TOWN OF BLUFFTON

STAFF REPORT

MEETING DATE:	June 28, 2023
PROJECT:	Refuel 1062 Bluffton: Landscaping, Lighting and Architecture Certificate of Appropriateness Highway Corridor Overlay
PROJECT MANAGER:	Katie Peterson, AICP Senior Planner

1. **COFA-04-23-017905.** A Certificate of Appropriateness to permit the landscape, lighting and architecture for Refuel convenience store and gas station, located along SC Highway 46 across from the May River Xing intersection. It is zoned PUD within the New Riverside PUD and New Riverside Village Master Plan.

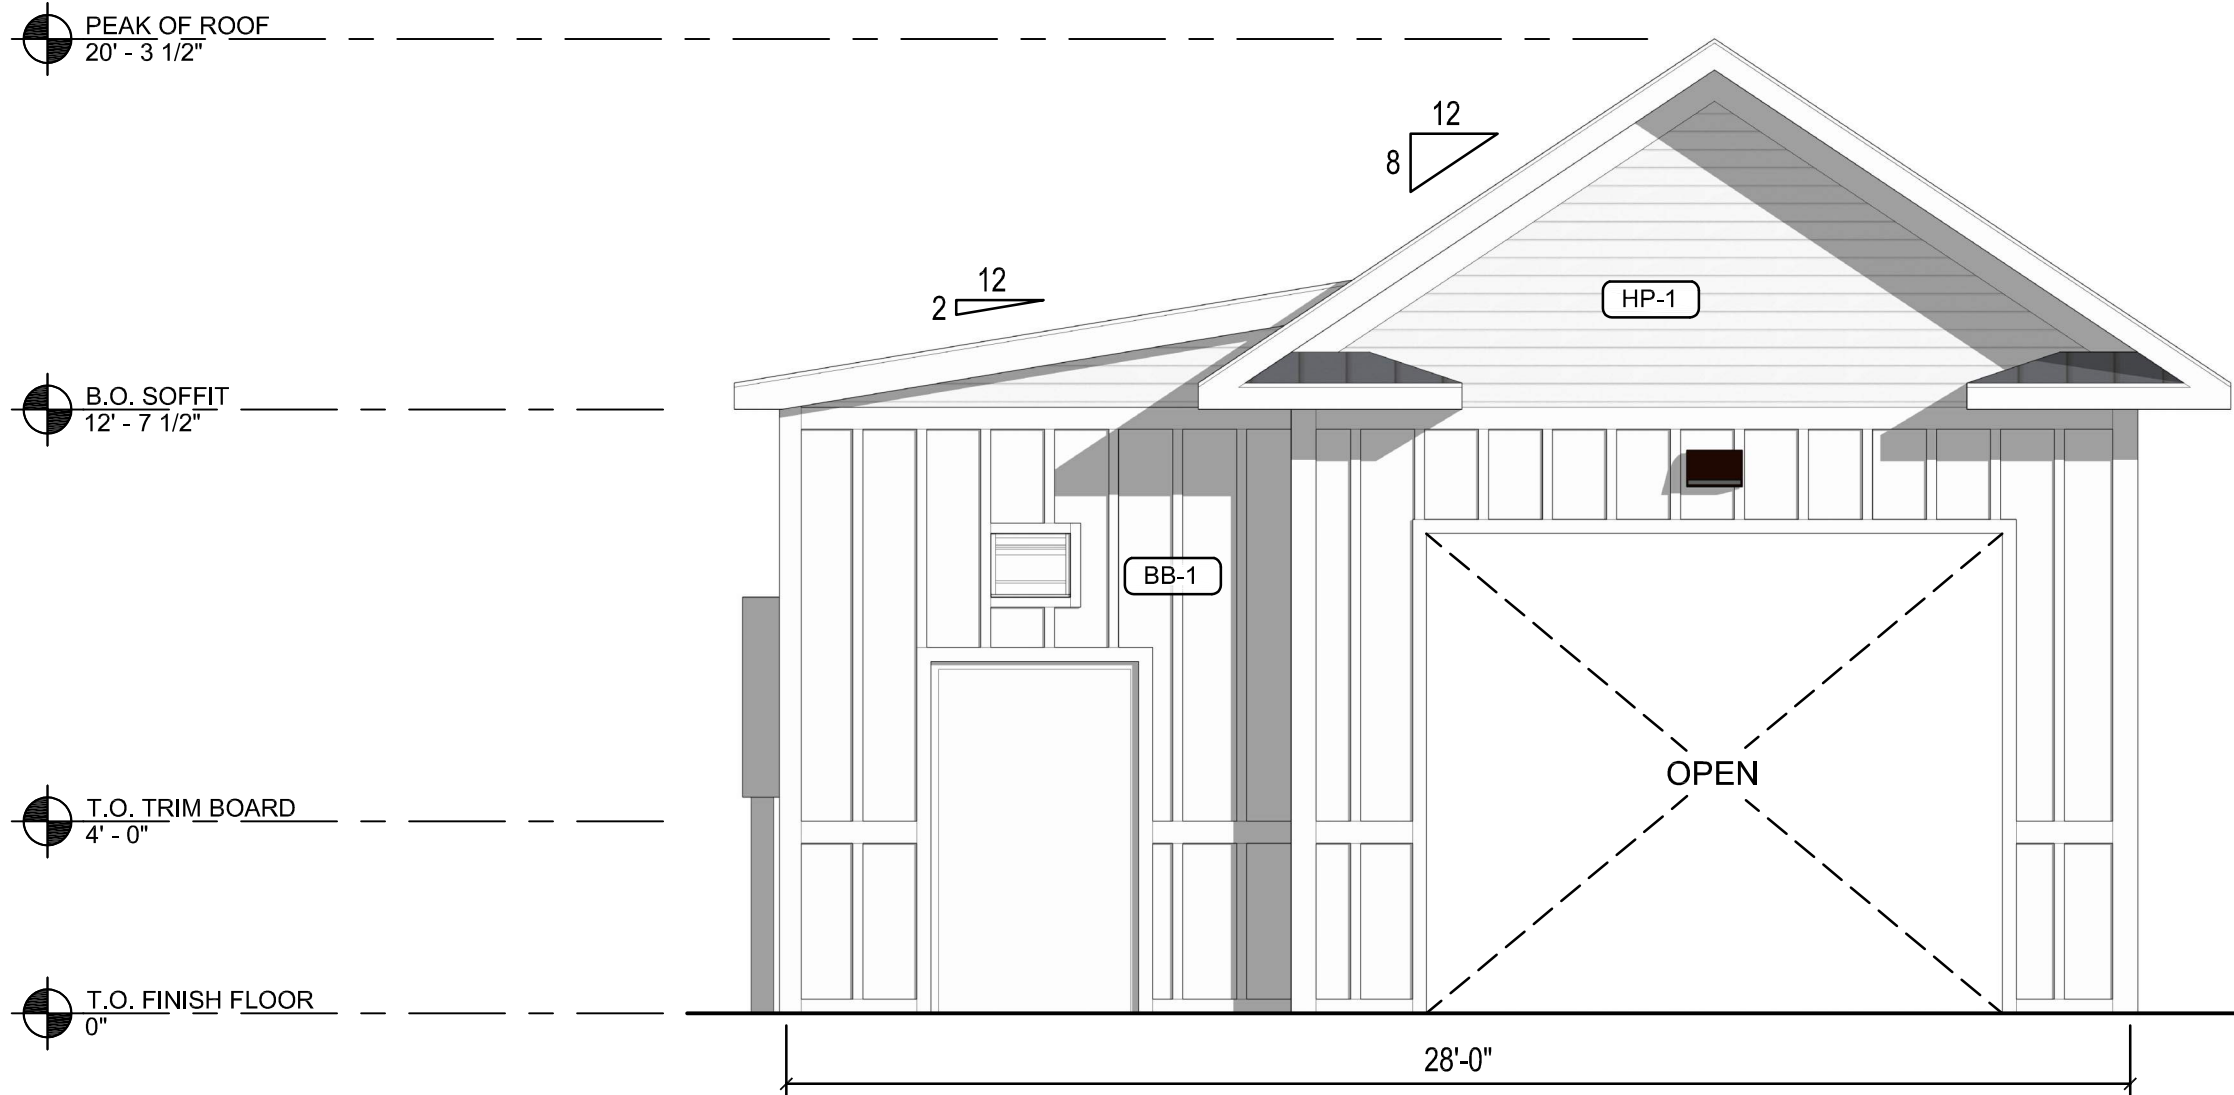
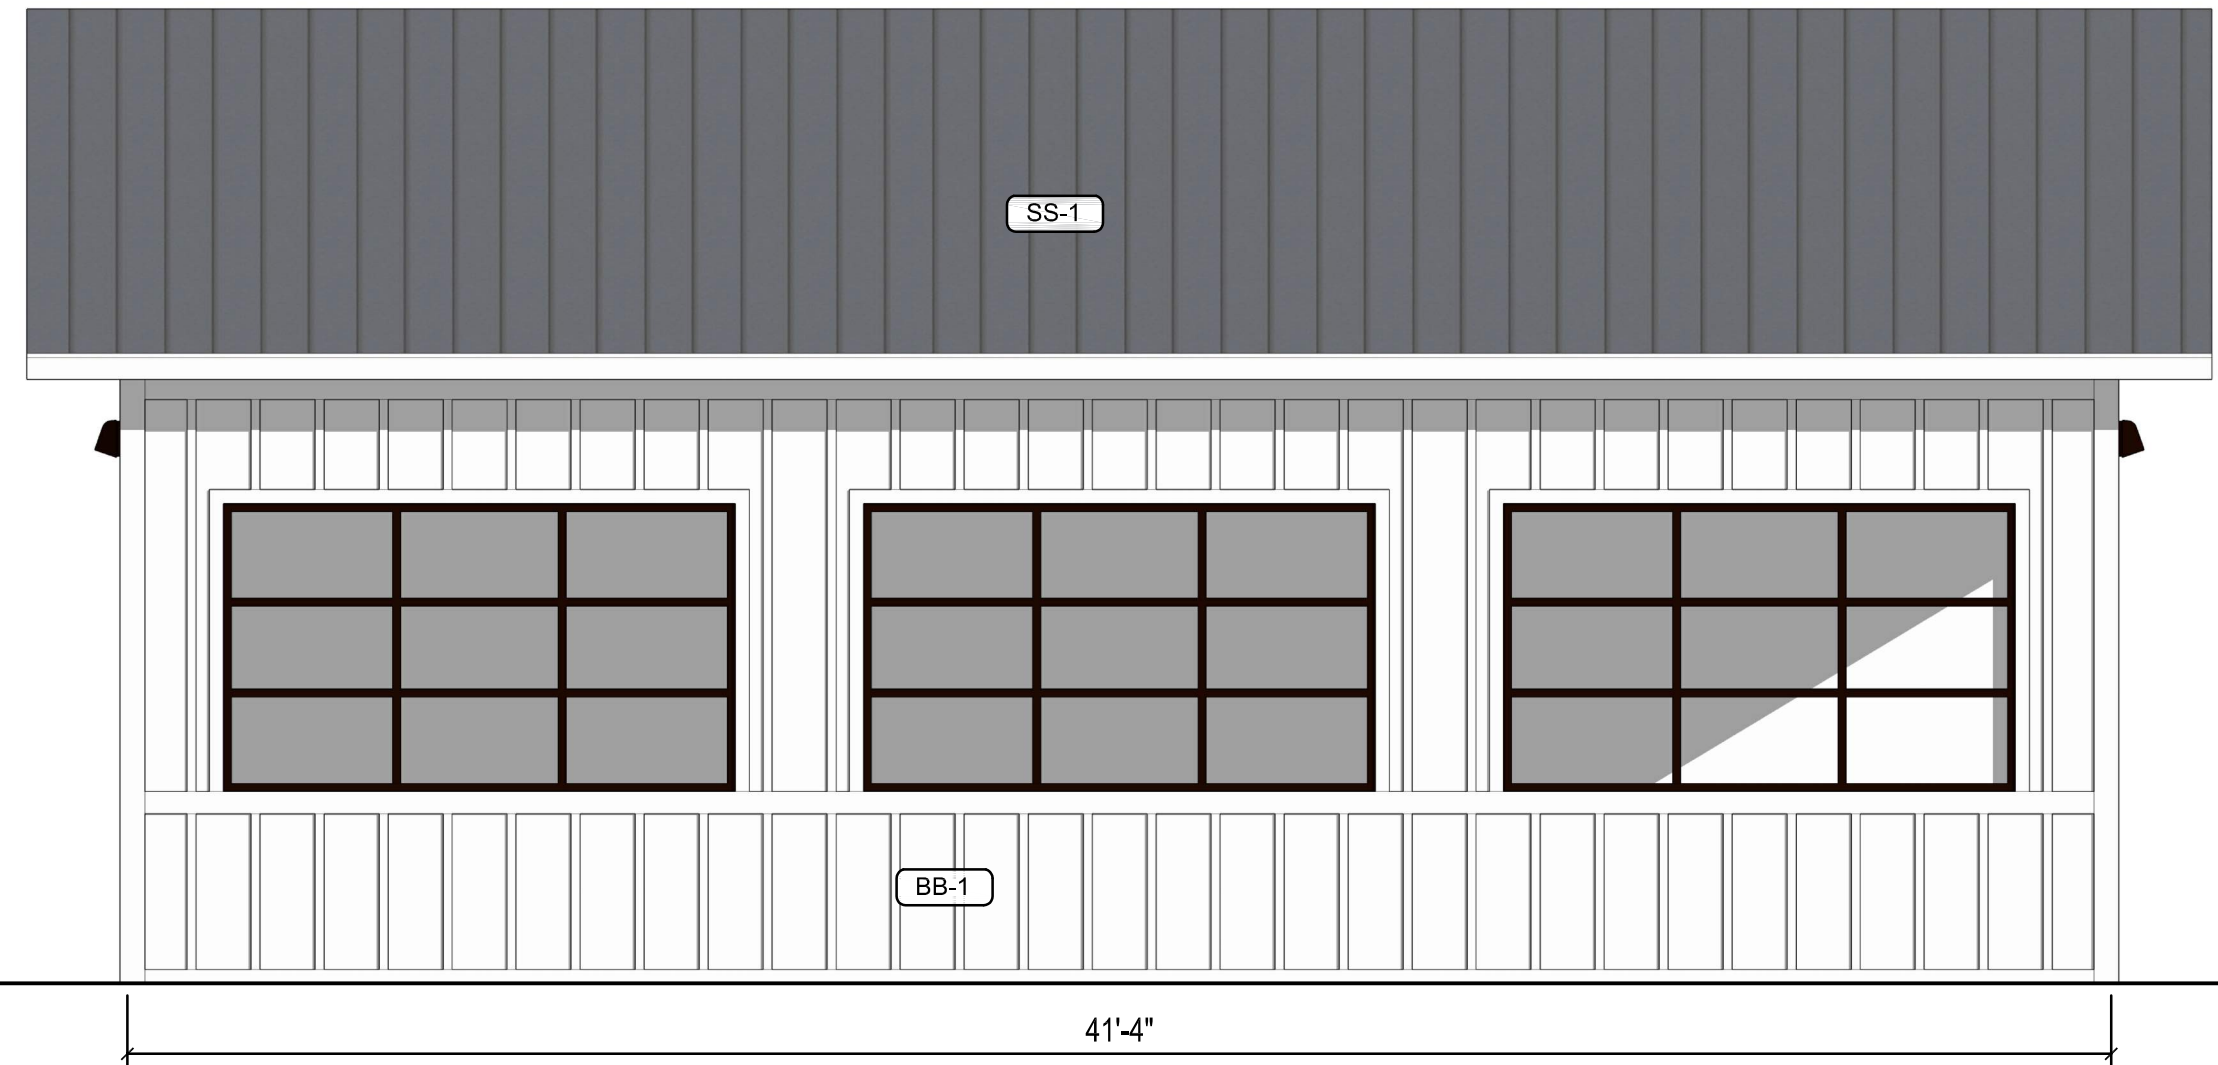
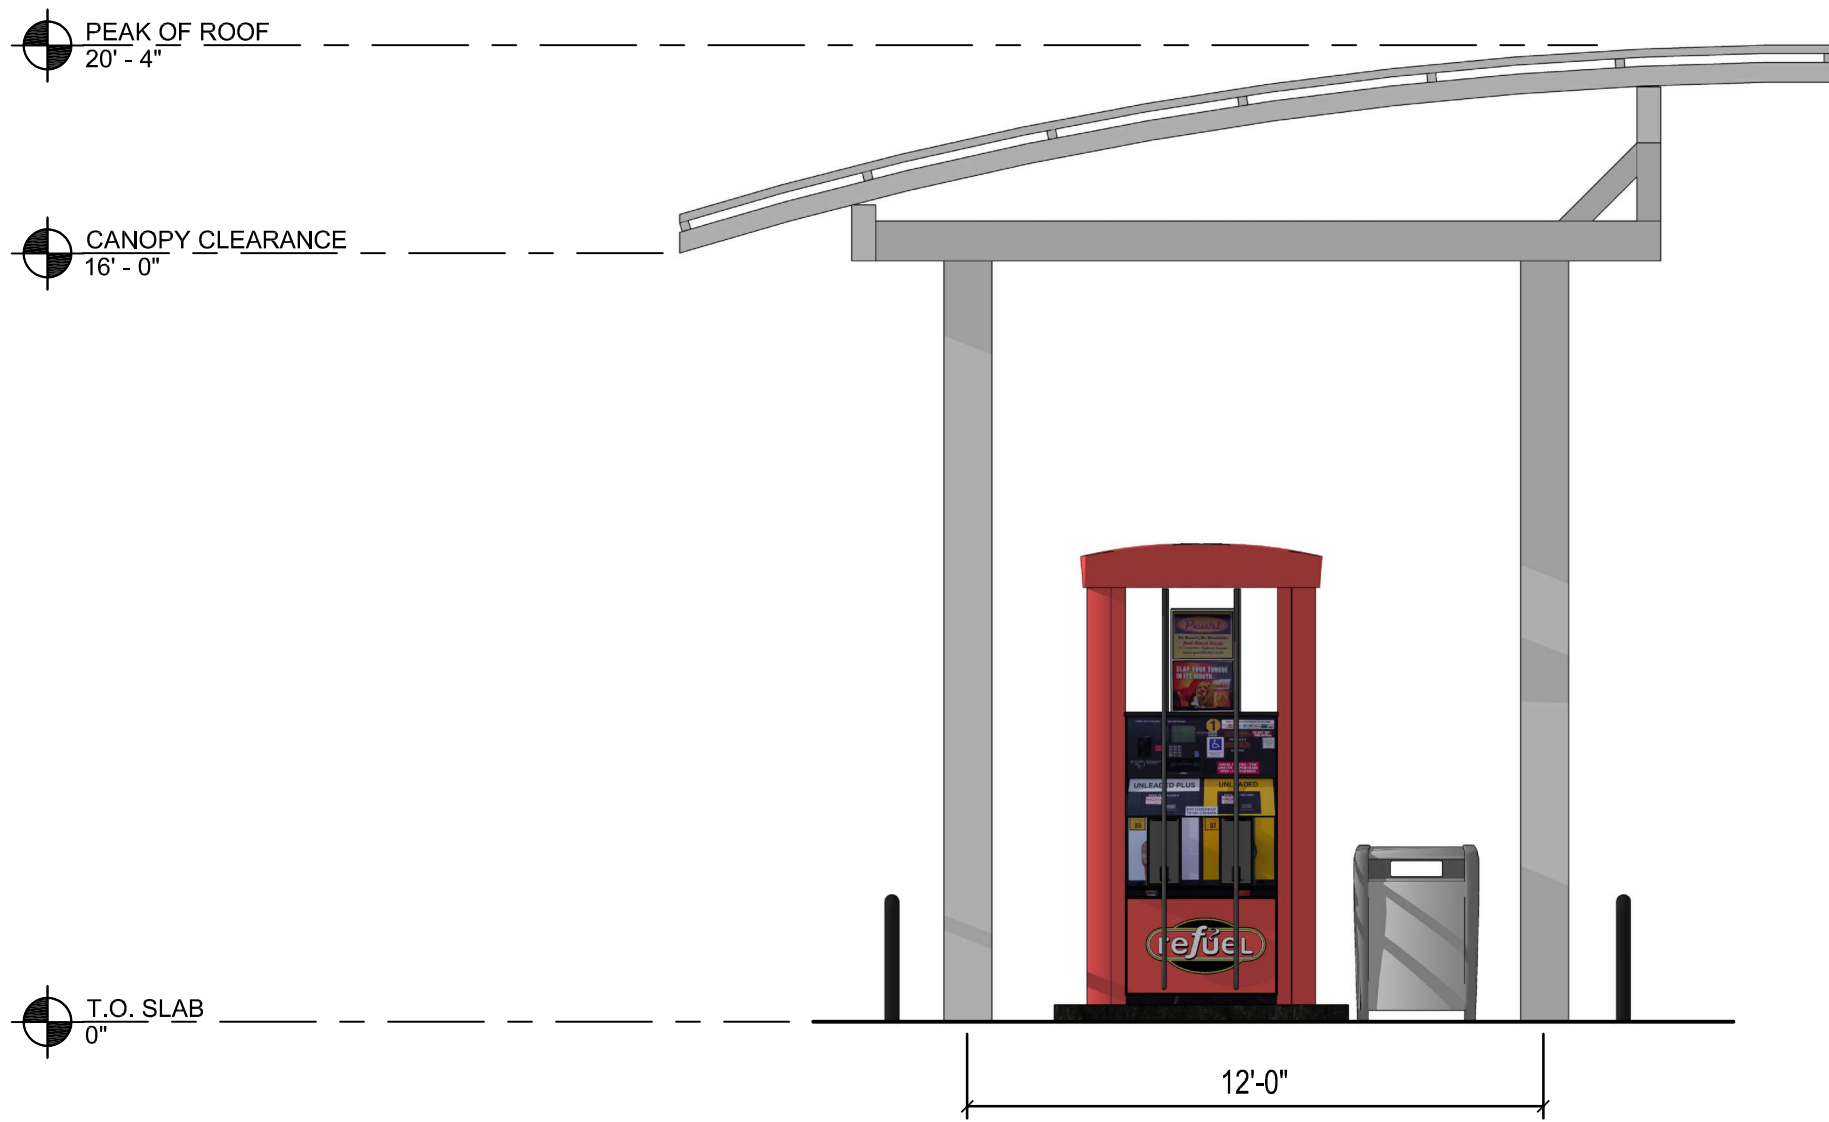
- 2) *Finding* – Appropriate Exterior Materials. Per Section 5.15.9.(D)(2) pitched roofs are defined as 4 and 12 pitch or greater. The carwash proposes the use of a 2 and 12 pitched roof. The roof pitch must be increased to meet this requirement. Further, a determination on the appropriateness of the curved gas canopies must be made, as they are not a typical roof type to the Lowcountry.

- b. Per Section 5.15.9.(D)(2), the 2 and 12 pitched roof must be revised to a minimum of 4 and 12.
 - c. Per Section 5.15.9.(D)(2), a determination on the appropriateness of the curved gas canopies must be made, as they are not a typical roof type to the Lowcountry.
